ADDENDUM NO. 1

RED CLAY CONSOLIDATED SCHOOL DISTRICT
WILLIAM F. COOKE, JR ELEMENTARY SCHOOL
2025 Graves Road, Hockessin, DE 19707

THE WHITING-TURNER CONTRACTING COMPANY
CONSTRUCTION MANAGER
131 Continental Drive – Suite 404
Newark, DE 19713
302-292-0676 (phone)
302-292-0683 (fax)

CSK009

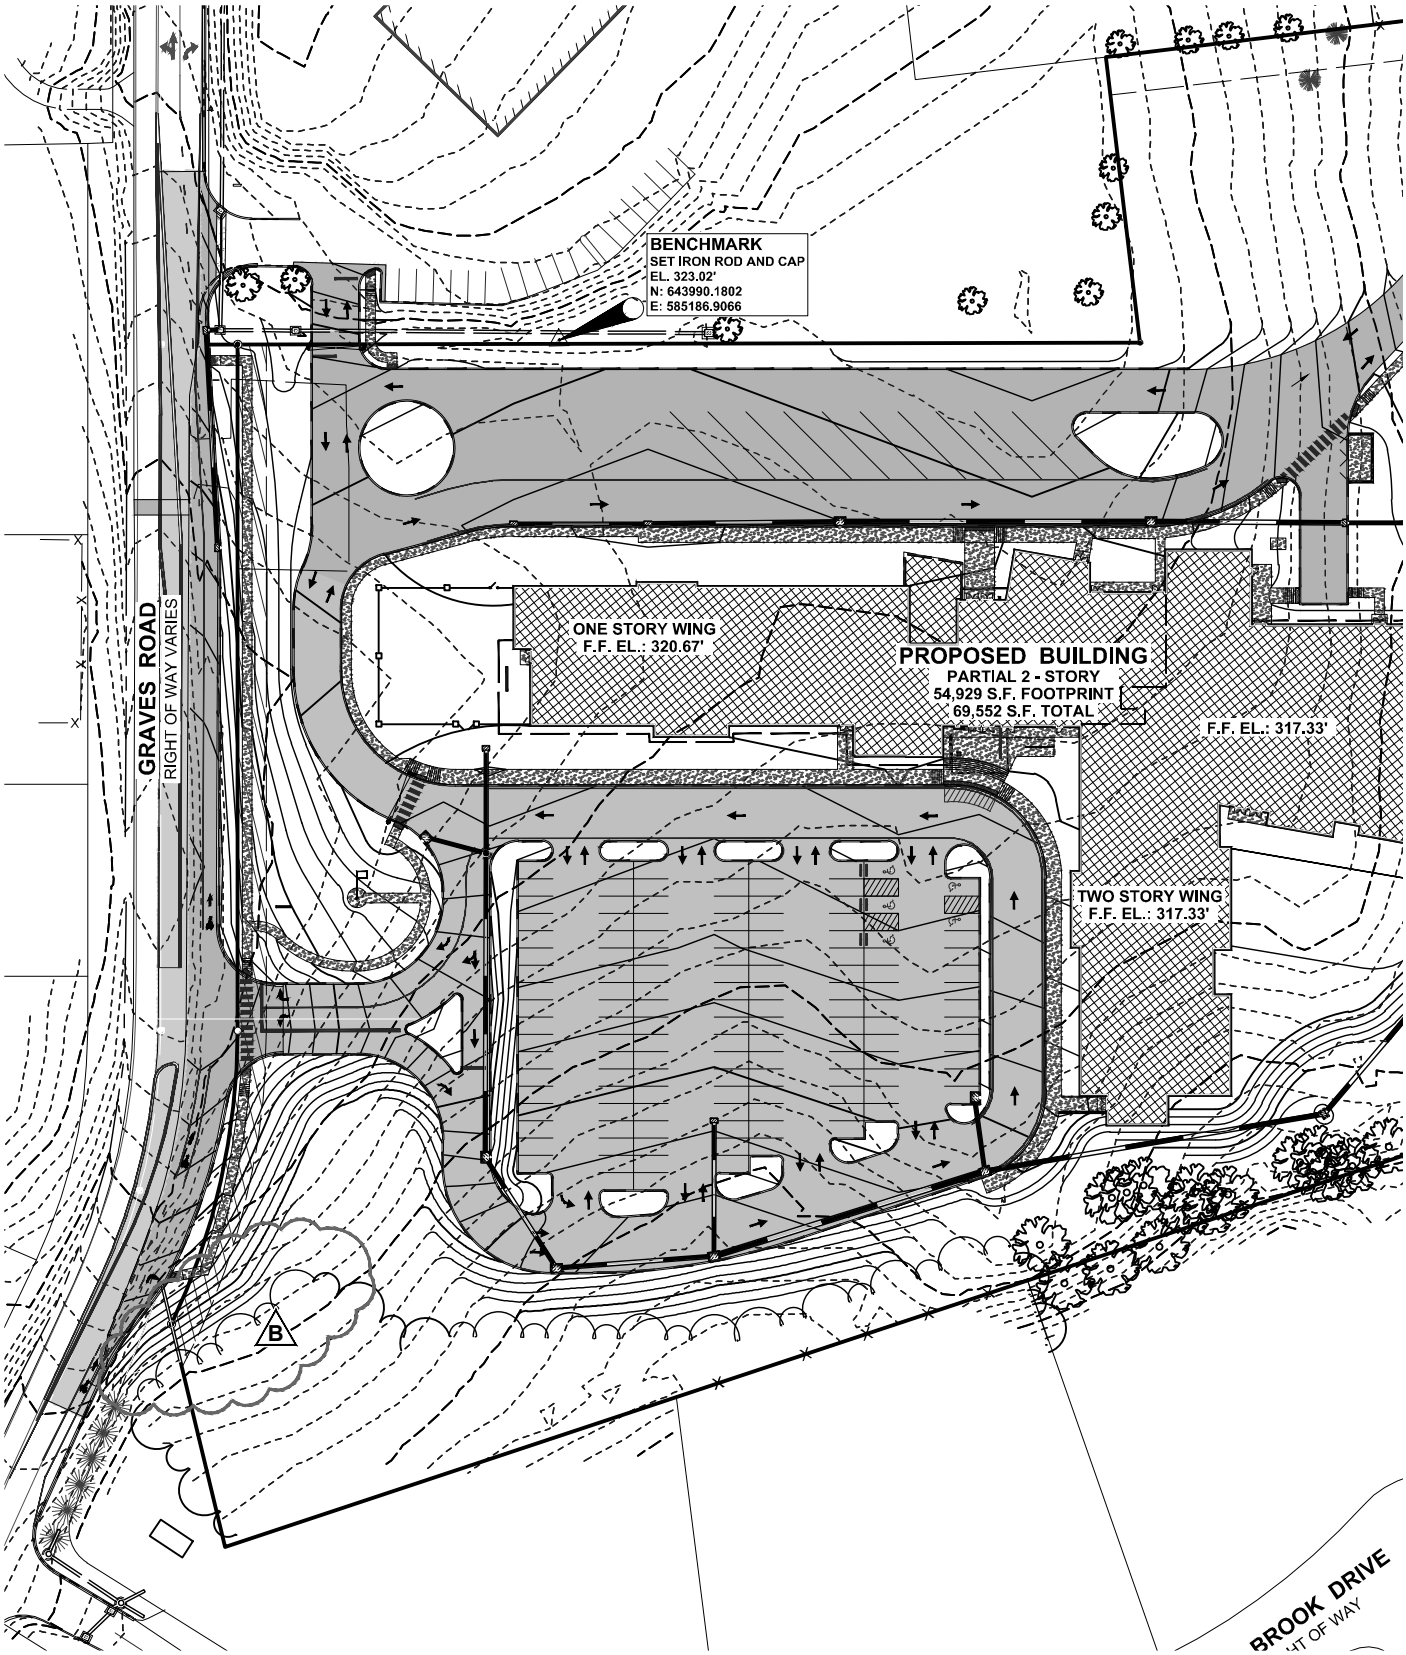
3.11.3 REVISE erosion and sediment control legend to include tree protection symbol per attached sketch CSK009.

CSK010

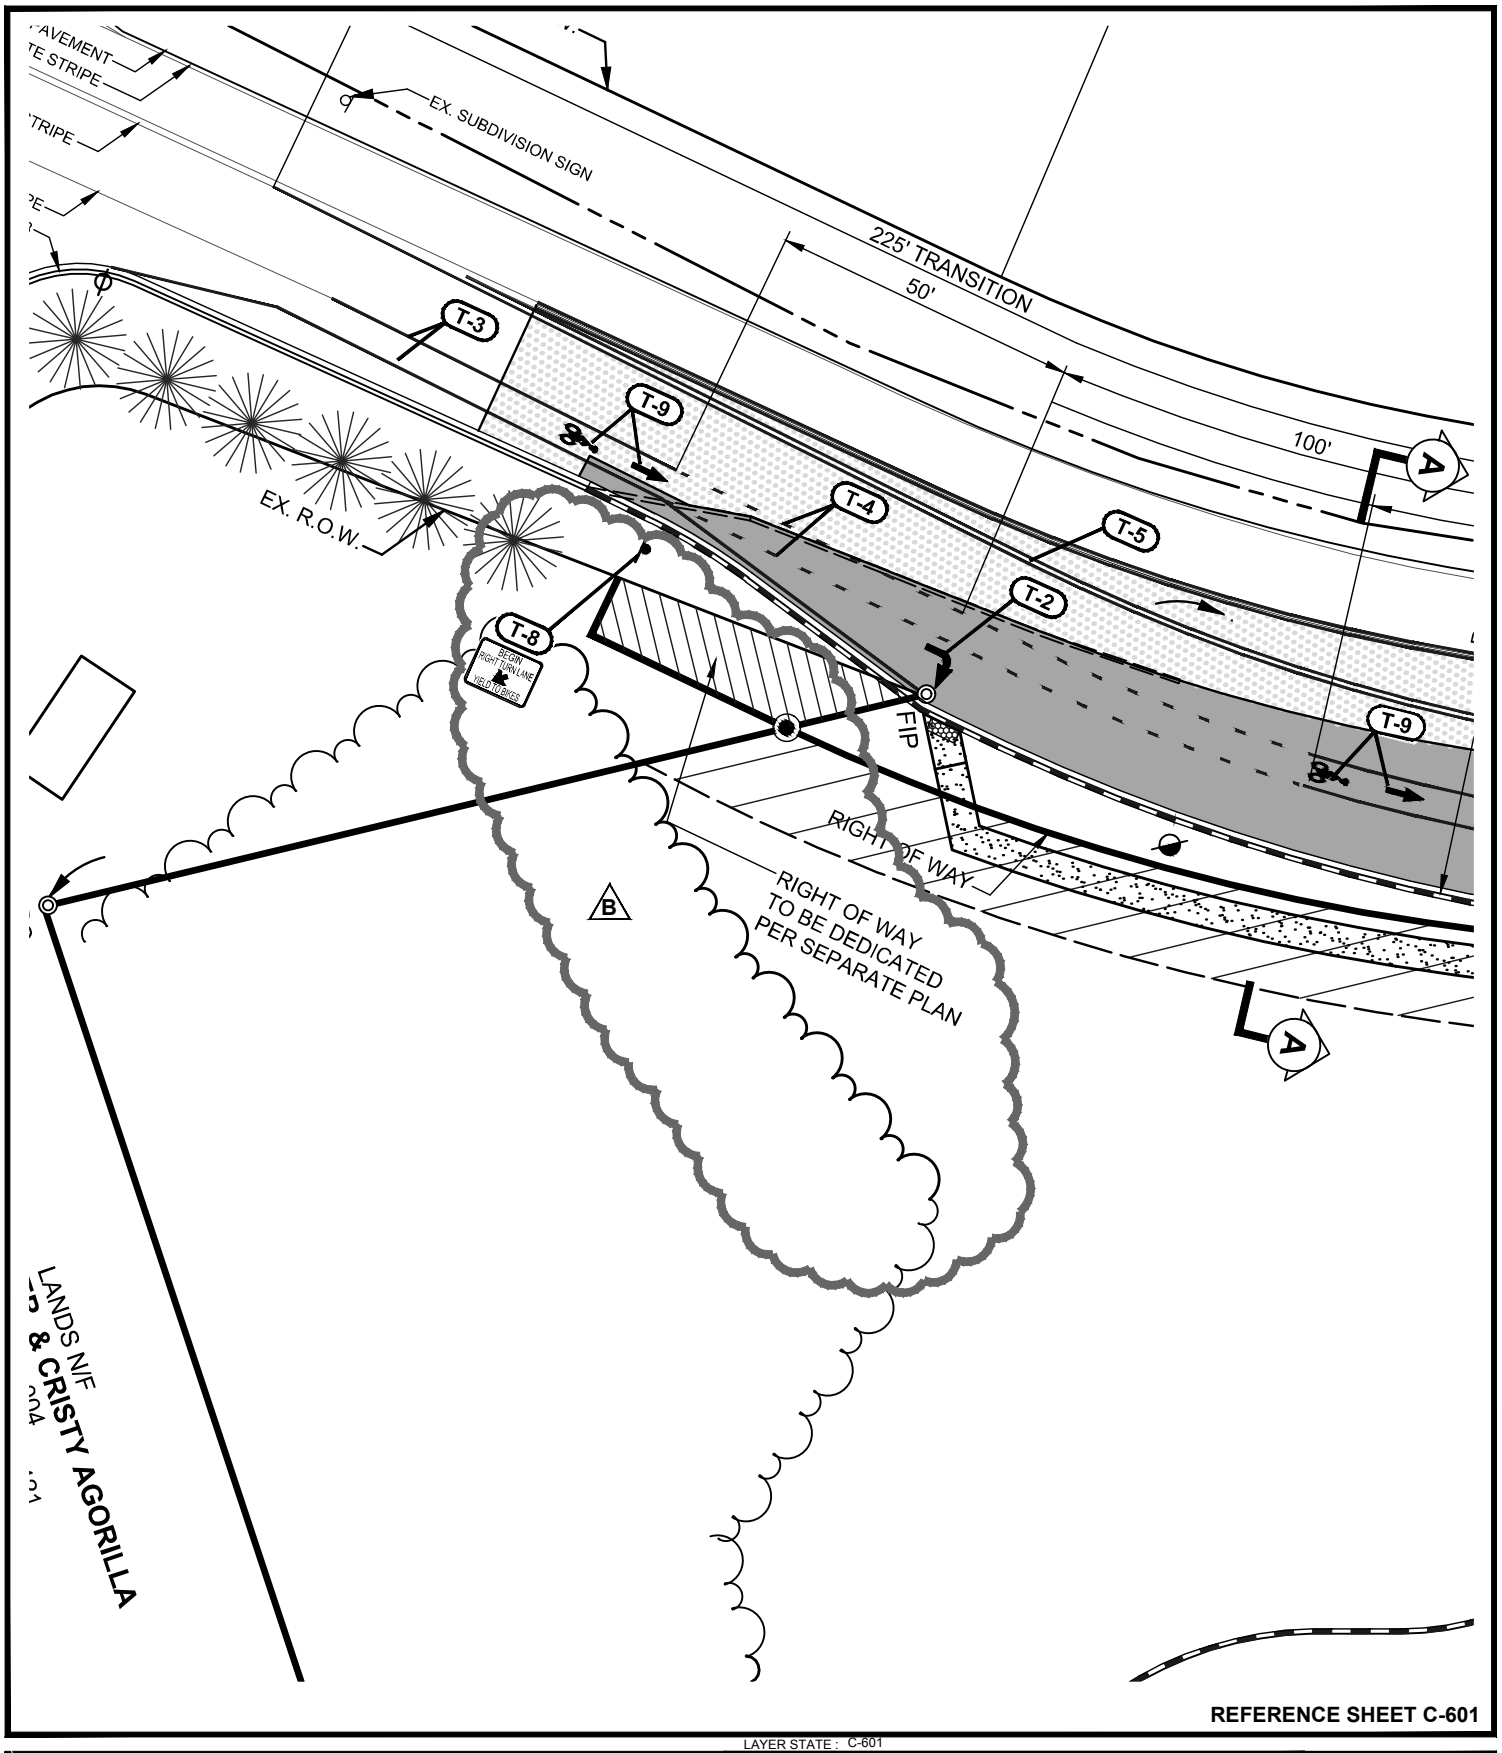
3.15 DRAWING C601 ENTRANCE SIGNAGE AND STRIPING PLAN
- 3.15.1 REVISE proposed new edge of wooded area at northwest corner of property along Graves Road (adjacent to Galster Property) per attached sketch CSK010.

CSK012

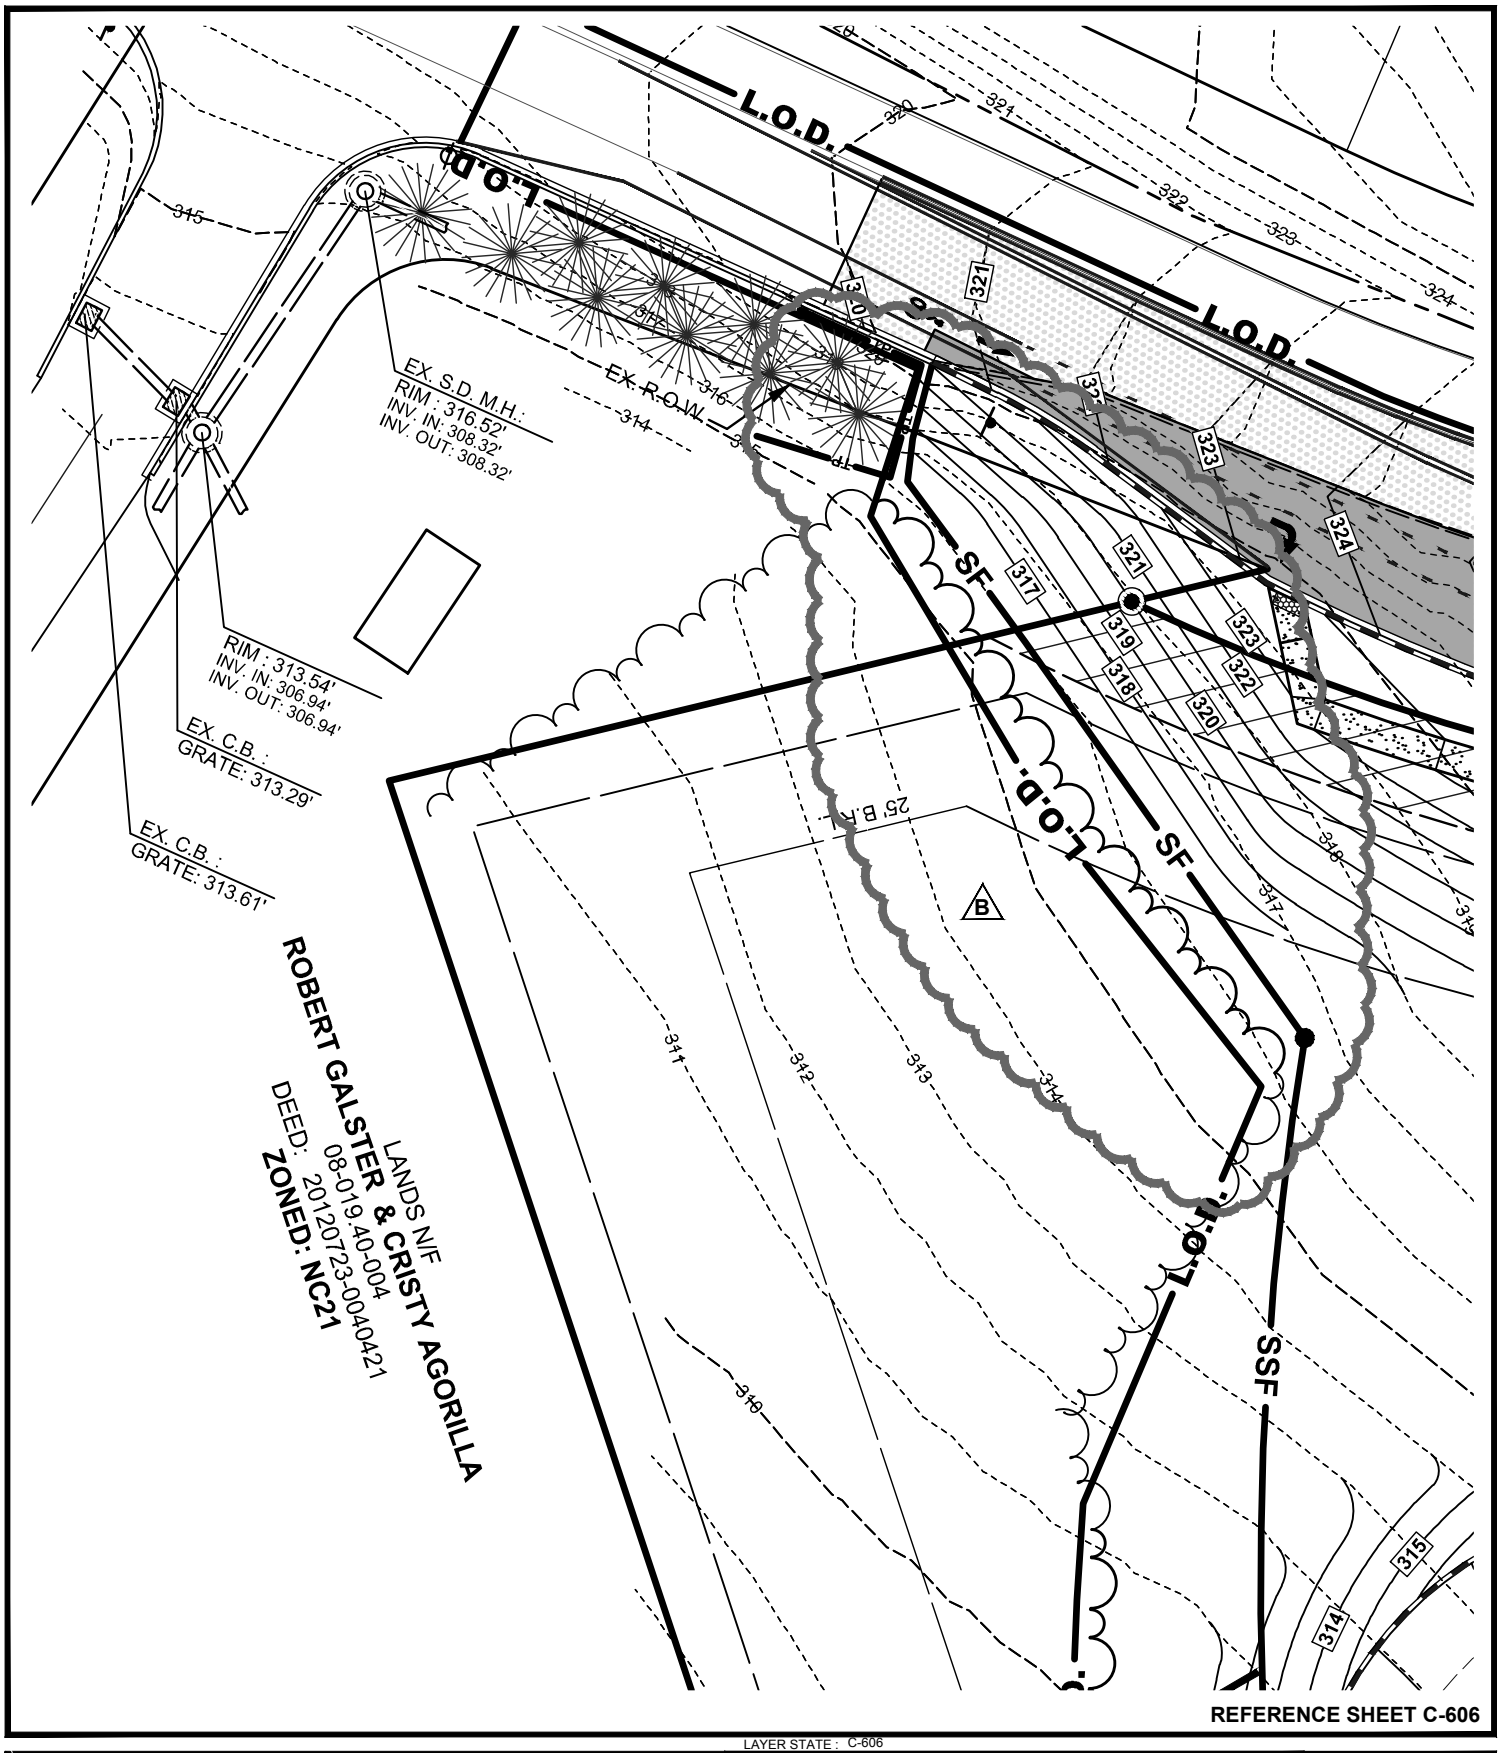
3.16 DRAWING C606 ENTRANCE SEDIMENT AND STORMWATER MANAGEMENT PLAN
- 3.16.1 REVISE erosion and sediment control legend to include tree protection symbol per attached sketch CSK009.
- 3.16.2 REVISE proposed new edge of wooded area at northwest corner of property along Graves Road (adjacent to Galster property) per attached sketches CSK012 and CSK013.
- 3.16.3 REVISE grading at northwest corner of property along Graves Road (adjacent to Galster property) per attached sketches CSK012 and CSK013.
- 3.16.4 REVISE L.O.D. line, silt fence locations per attached sketches CSK012 and CSK013.

CSK014

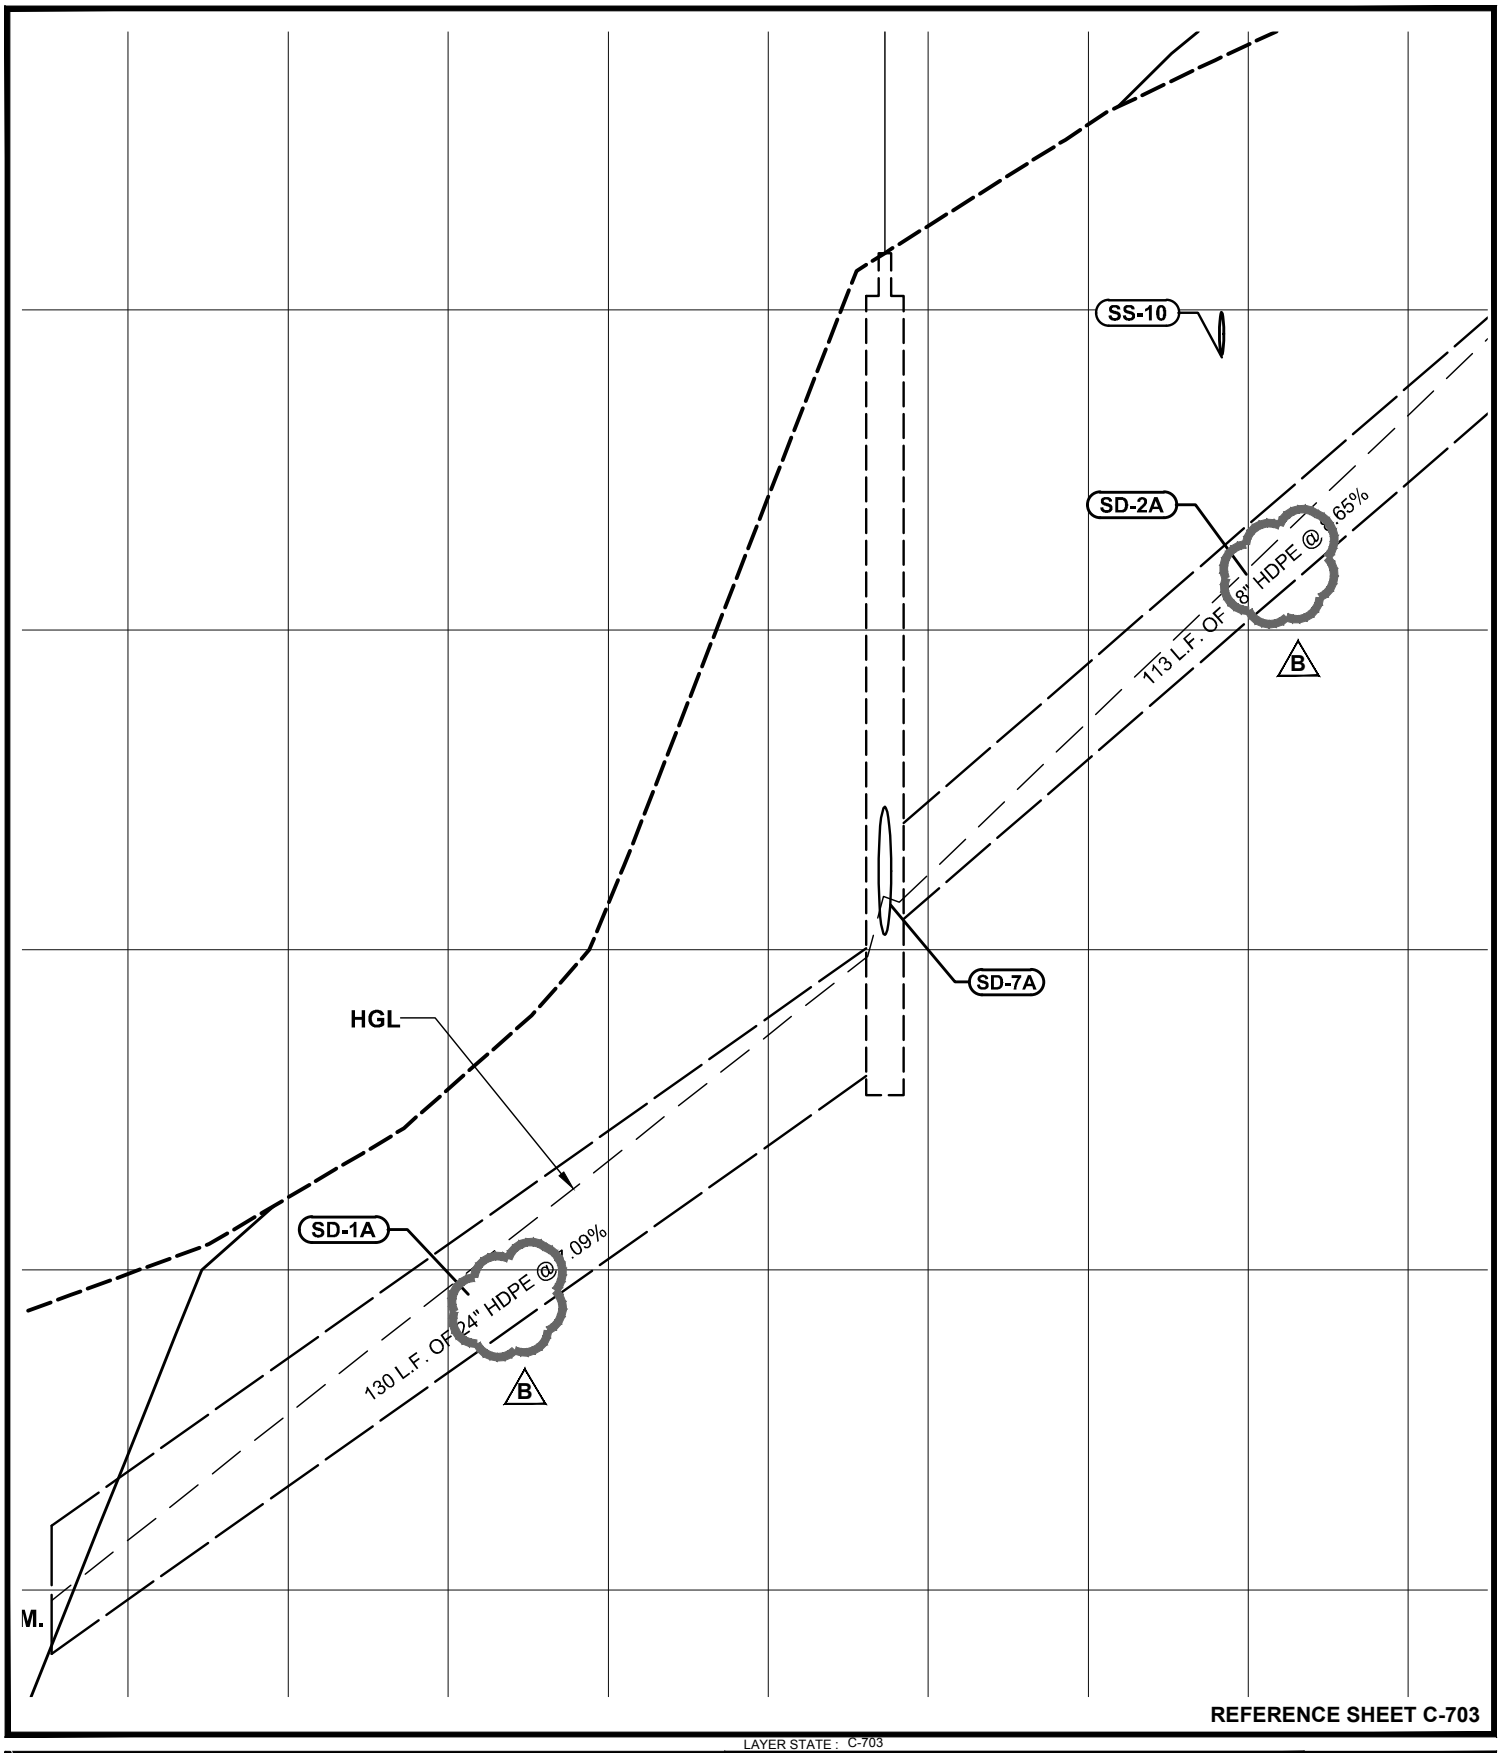
3.20 DRAWING C703 STORM WATER DRAIN PROFILE SD-7A to SD-17A
3.20.1 REVISE SD-1A and SD-2A pipe material to "HDPE" to match storm drain pipe schedule per attached sketch CSK014.
